4.0 DESIGN DEVELOPMENT

4.9 HEIGHT & MASSING

Excerpt from Pre-application Addendum 2 - March 2022

Section - As previously submitted

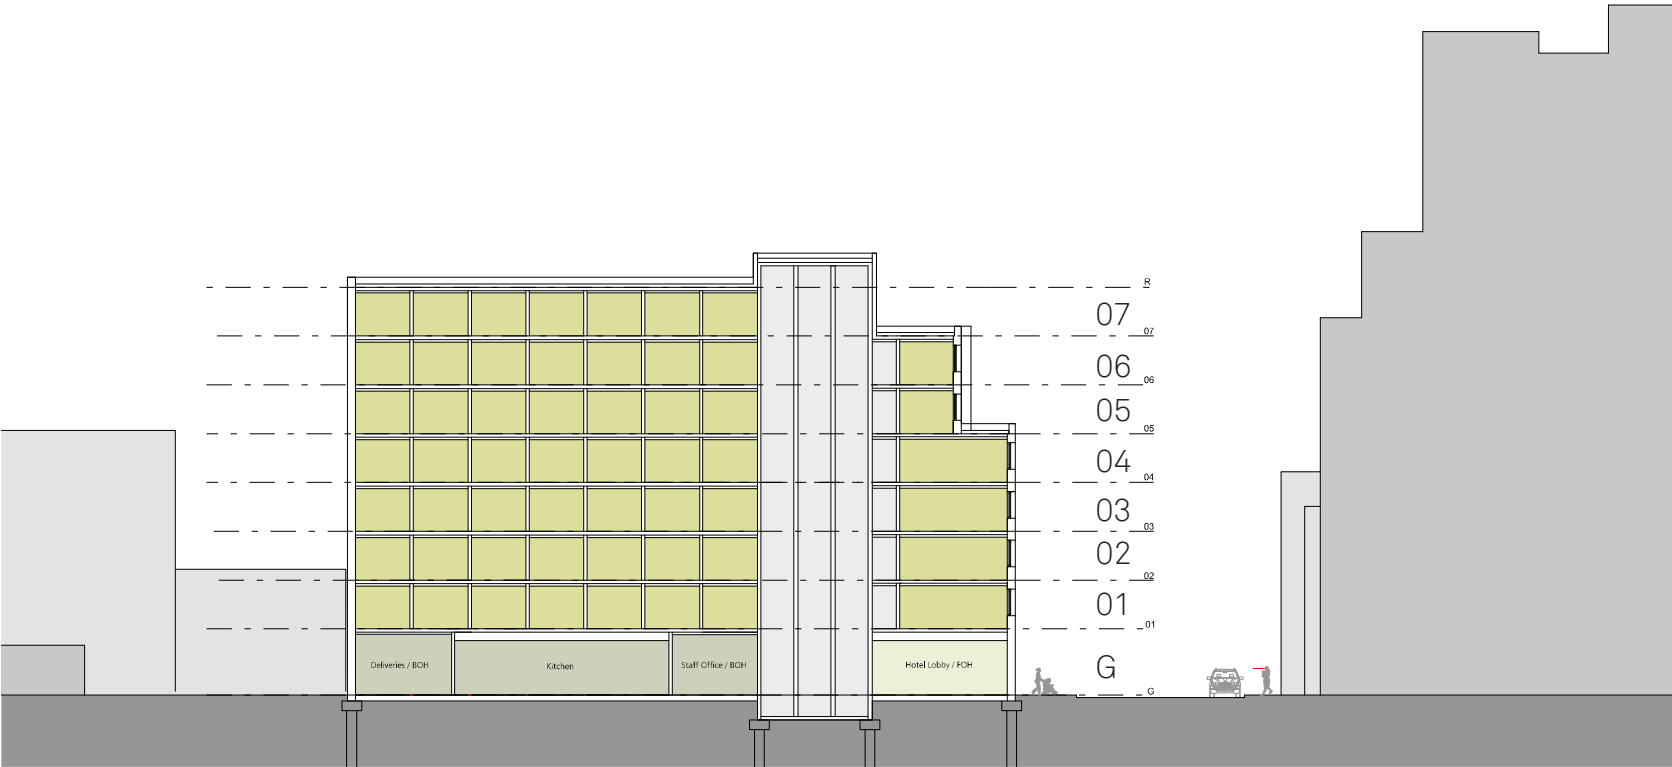
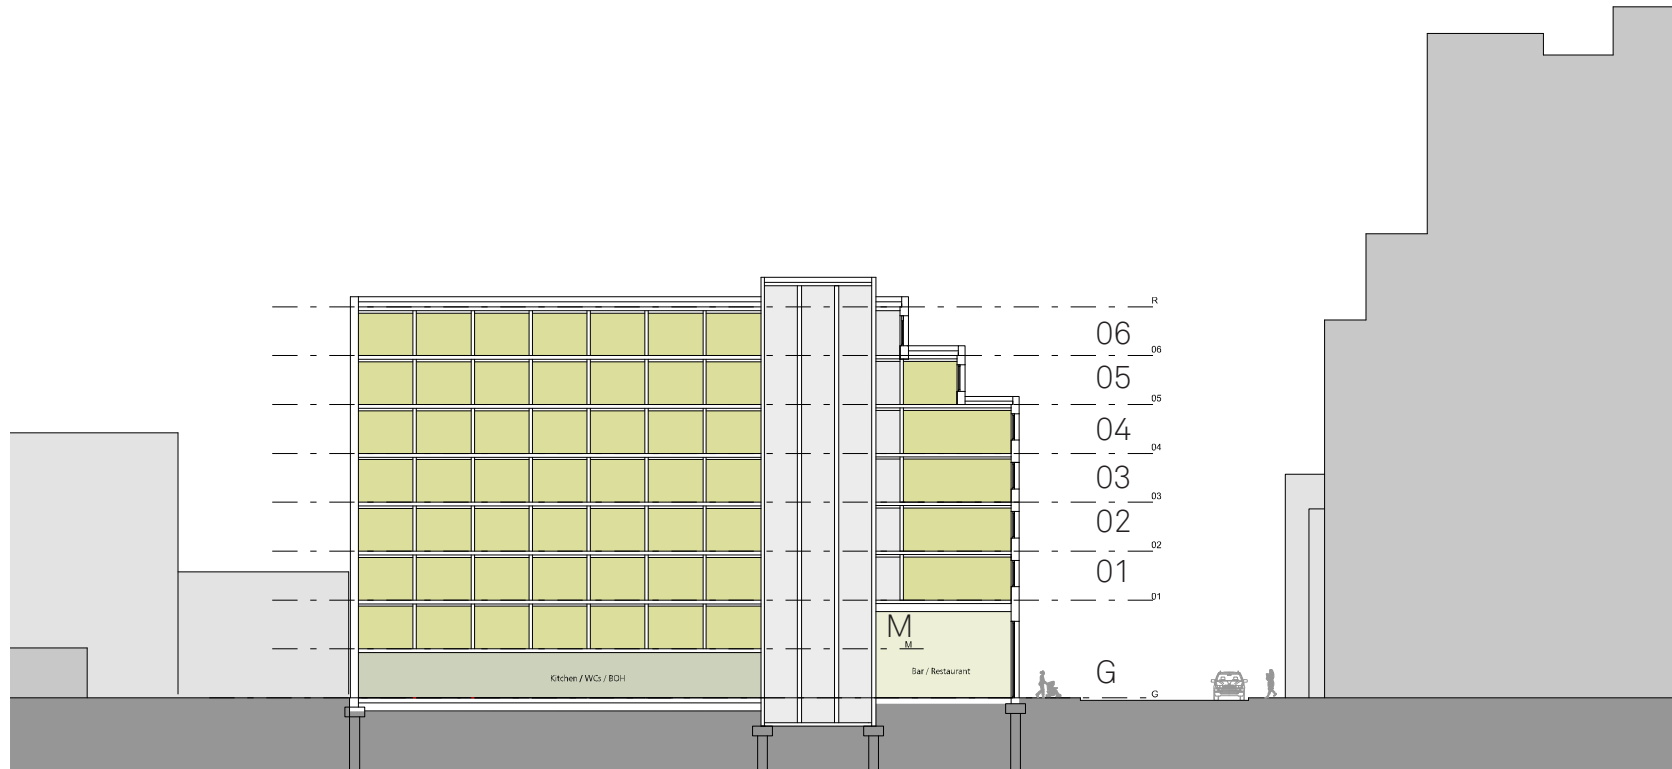
Officer comment

Can the overall height be reduced from G+7 to G+6 and an additional set-back introduced at level 6.

The previous pre-application submission proposed G+7. The top floor has been removed and the overall height has been reduced and the scheme now proposes G+6.

The ground floor has been replanned to incorporate a mezzanine level in place of double height back-of-house spaces. This has created for a more generous double height F&B offering along Friar Street, whilst allowing for a reduction in height of accommodation at the rear.

A further set-back has also been introduced at level 6 that was also requested by officers.

As per officer request, a floor has been removed (G+7 to G+6) and the 6th floor has been set back – these changes have addressed the officer change request.

Proposed section - As previously submitted

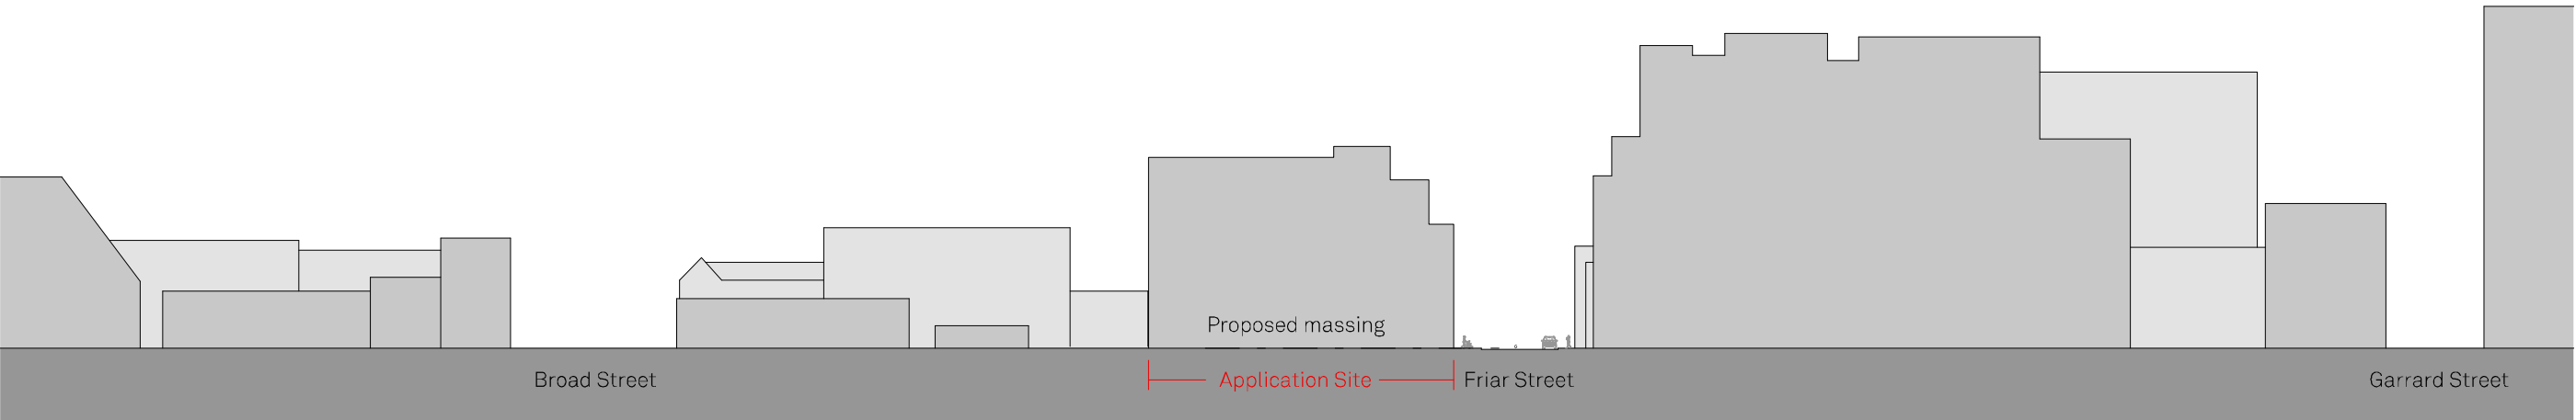
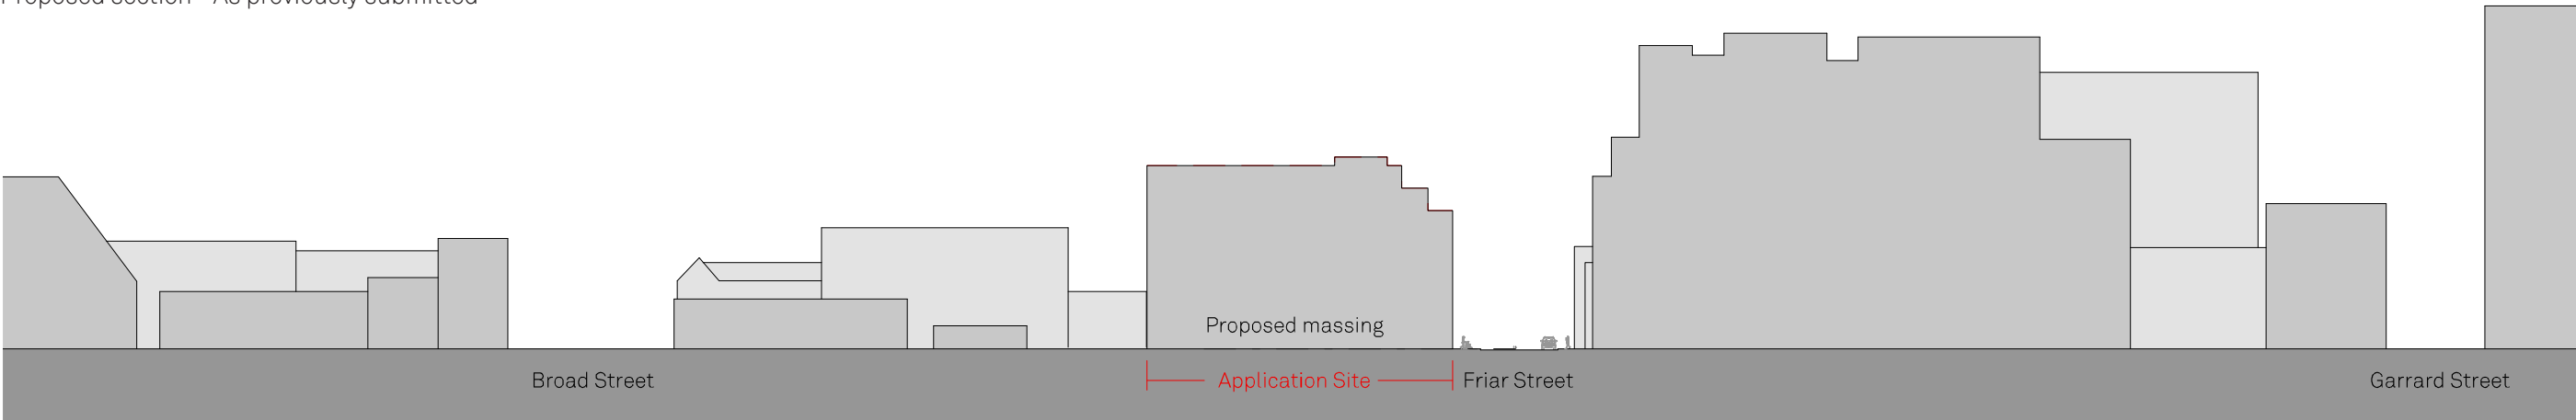
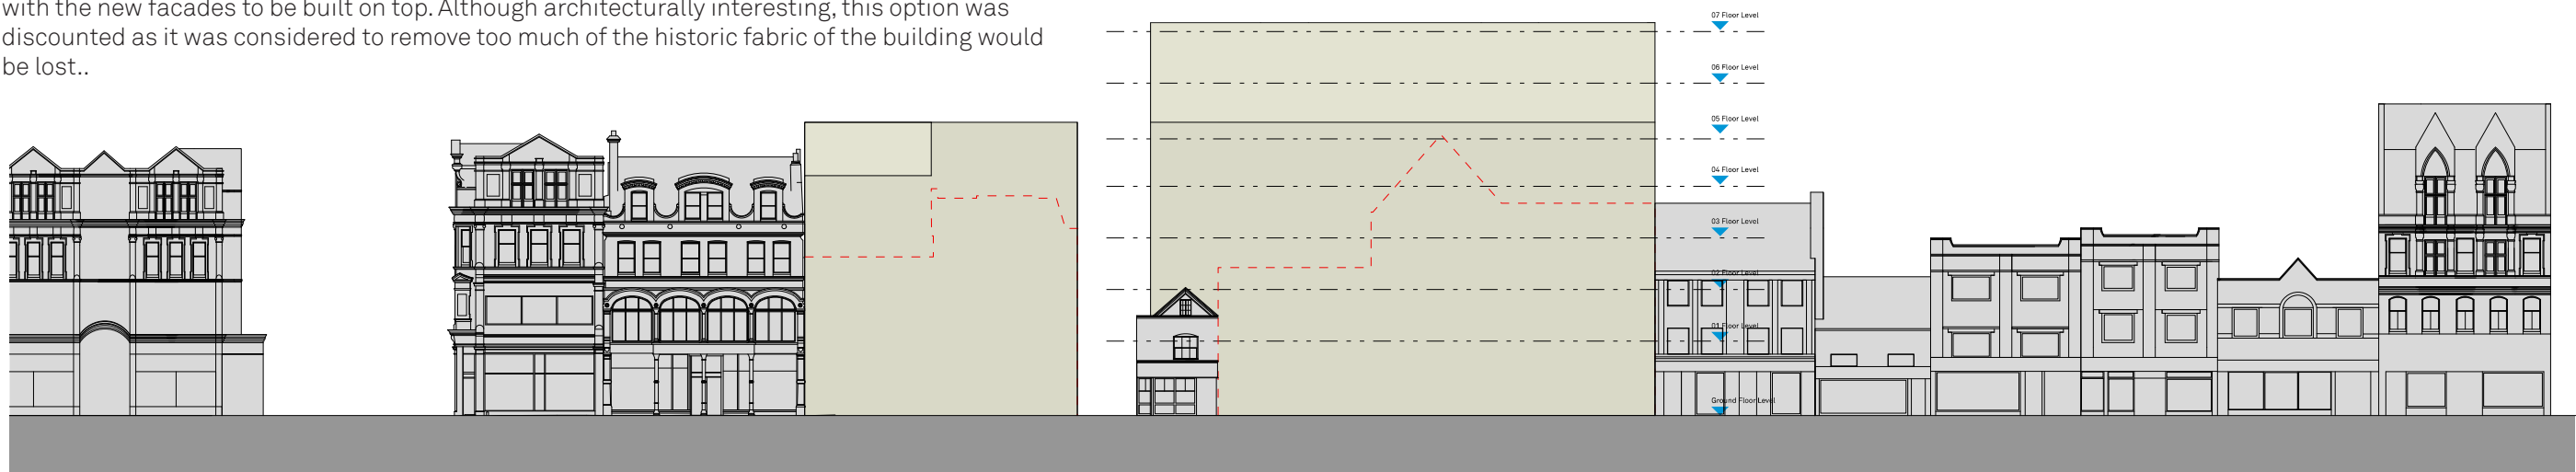
Officer comment:
Concerns over visual impact of G+7 storey building height on the site. Can the proposal be reduced to G+6 storeys.

Design Team response:
Top floor removed to allow for G+6 storey proposal with loss of accommodation mitigated through introduction of a mezzanine level and additional rear wing. The updated contextual section previously requested by Officers is presented here.

Summary:
The overall height of the building has been reduced as per officers request.
